PJM Manual 14D:

Generator Operational Requirements

~~Revision: 59~~ Revision: 60

Effective Date: ~~September~~ October 1, 2022

Exhibit XXX. An example of real-time data and account metering requirements for a Mixed Technology Facility, including measurement points. This facility is 75 MW or larger and

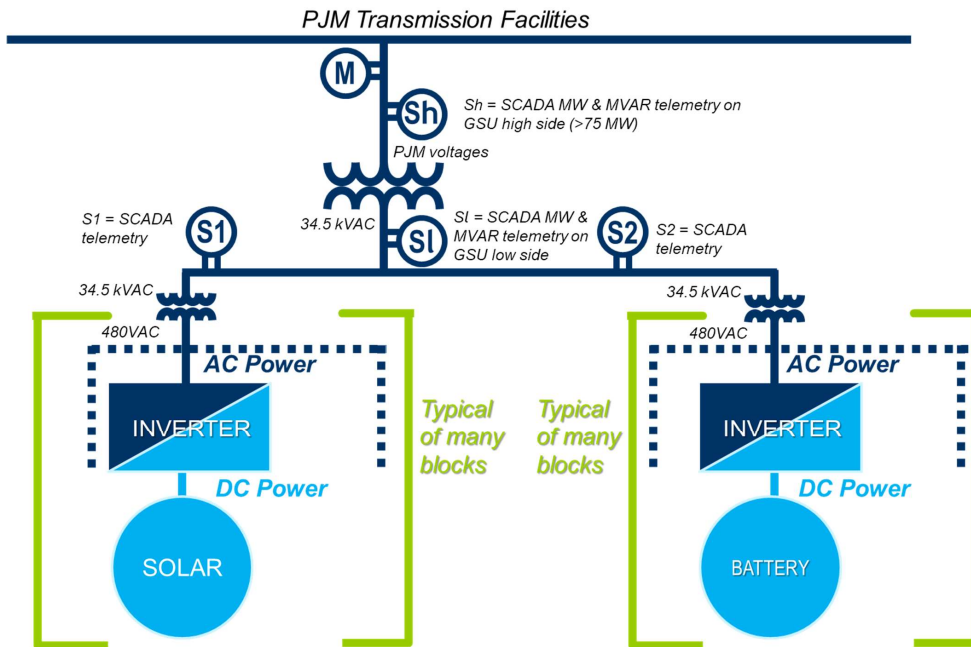
A Mixed Technology Facility shall have metering that measures non-real-time or revenue information corresponding to the Point of Interconnection (shown as "M" in Exhibit XXXX below). This metering shall meet the accuracy requirements for primary billing metering systems specified in Manual 01 section 5.3.2 (or other section of that manual as may be applicable). A Mixed Technology Facility participating in markets as multiple Co-Located Resources requires non-real-time MWh revenue information for each Co-Located Resource. Such MWh quantities may be calculated by apportioning the MWh measured for the entire Mixed Technology Facility across the Co-Located Resources. Such apportionment may be achieved pro rata based on the real-time MW telemetry for each Co-Located Resource.

Exhibit XXXXX below illustrates an example of a Mixed Technology Facility with a solar resource and an Energy Storage Resource, each participating separately in markets as a Co-Located Resource. In this example, all of the energy measured for the Mixed Technology Facility at "M" across an interval (e.g., 5 minutes) is split between the solar resource and the Energy Storage Resource pro rata according to the power measured at S1 (which measures all of the solar production) and at S2 (which measures all of the storage power flows) integrated over the interval.
